ORIGINATION FORM

Proposed Revisions to a Standard Plans Index
(Please provide all information – Incomplete forms will be returned)

Index Number: 450-045
Sheet Number (s): 1
Index Title: Florida-I 45 Beam - Standard Details

Summary of the changes:

ELEVATION

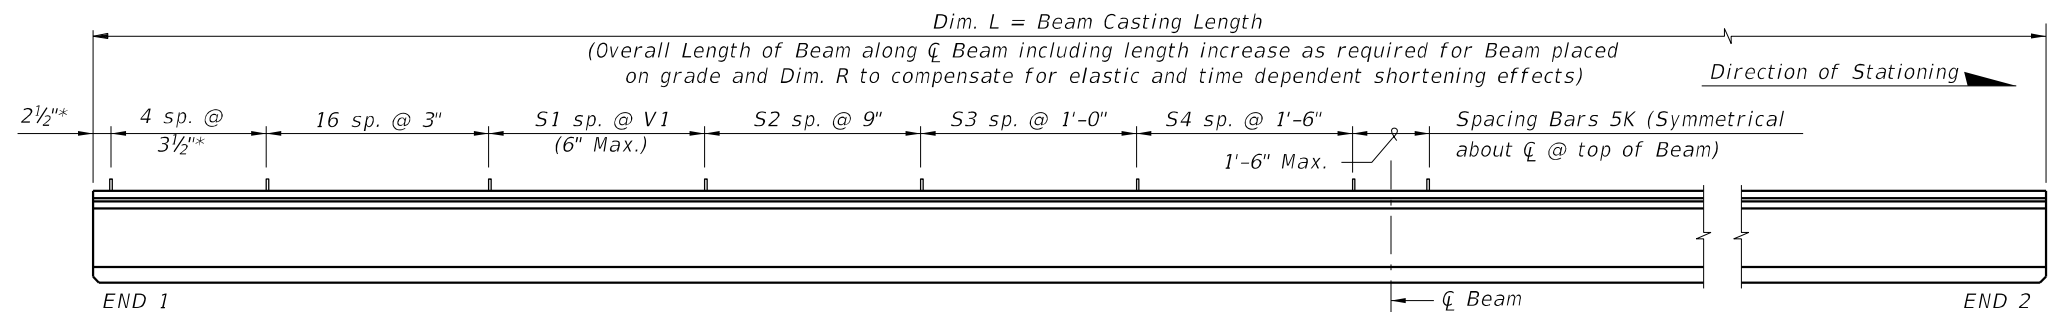
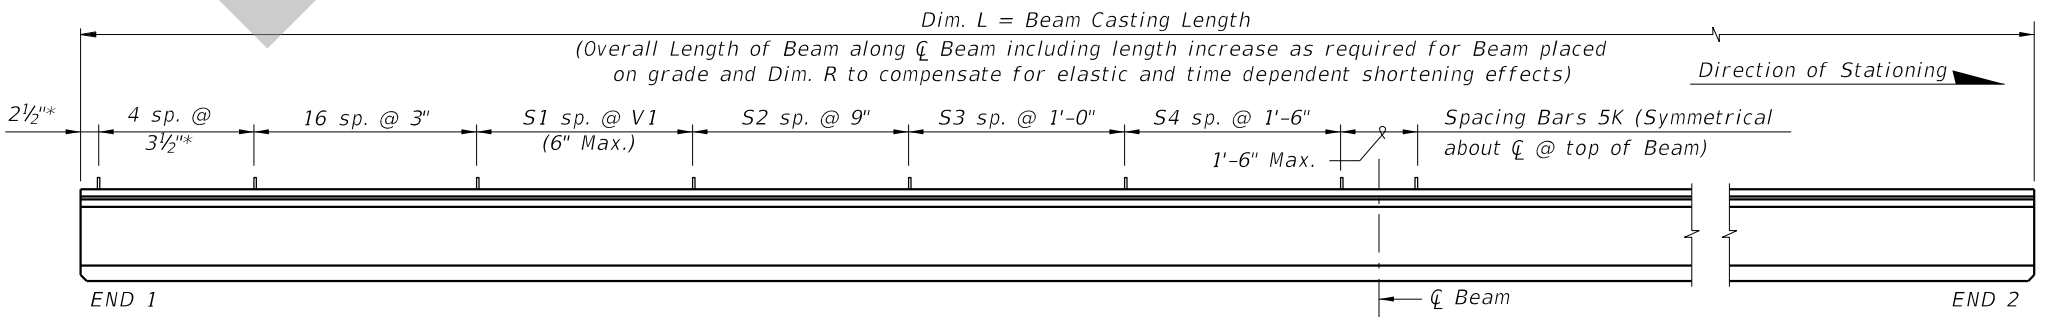
Deleted Intermediate Diaphragm Inserts

Diaphragms not required; therefore Inserts not required.
